WEST WHITELAND TOWNSHIP
Planning Commission
Agenda
Tuesday, June 9, 2020
7:00 P.M.

DATE: June 5, 2020
TO: Planning Commission
FROM: John R. Weller, AICP
Director of Planning and Zoning
SUBJECT: 690 E. Lincoln Hwy.
Conditional use application

SUBJECT: **REVIEW COMMENTS – WAWA 690 EAST LINCOLN HIGHWAY
CONDITIONAL USE PLAN DATED 4-10-20**

Figure 1 - Excerpt from Township Bicycle and Pedestrian Plan

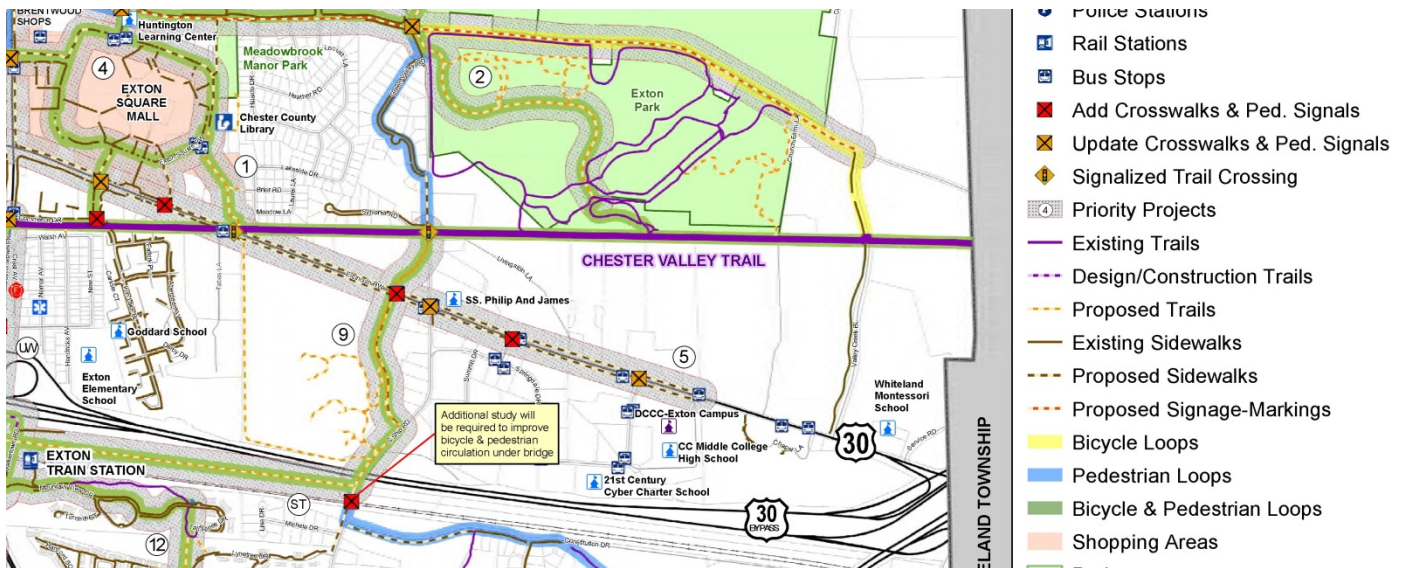
The plan lacks adequate multimodal accommodations as follows:

- a. Lincoln Highway – The plan includes no sidewalk and no pedestrian crossings along Lincoln Highway. There is no proposed means of pedestrian access from the west end of the site and Chester Valley Trail to the proposed commercial area and Saint Mary’s Church at the east end of the site. The plan shall be revised accordingly.
- b. Bicycle and Pedestrian Loop Trail – The plan indicates a five foot wide sidewalk along the proposed Ship Road Couplet. The sidewalk does not continue to the southern tract boundary along Ship Road, nor is any trail crossing signalization/infrastructure proposed at Lincoln Highway. The trail shall be provided at 12 feet width, extending fully through the property, and with the required Lincoln Highway pedestrian signal and crosswalk.
- c. Ship Road – No sidewalk is proposed along the Ship Road frontage.

The plan fails to meet the O/R district purpose of integrating residential and nonresidential uses and providing access by means other than private automobiles per section 325-15.1.A.1 (ZO). The conditional use plan requires revisions to demonstrate feasibility of compliance with pedestrian and bicycle accessibility standards.

Figure 1 - Excerpt from Township Bicycle and Pedestrian Plan

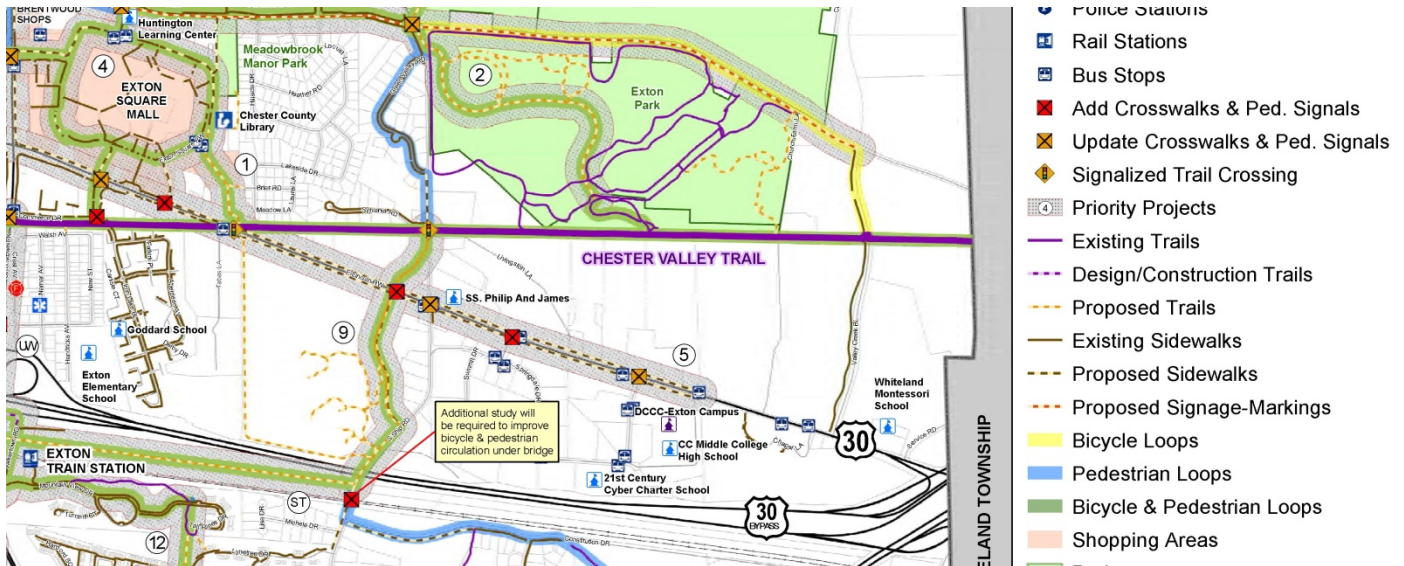
The plan lacks adequate multimodal accommodations as follows:
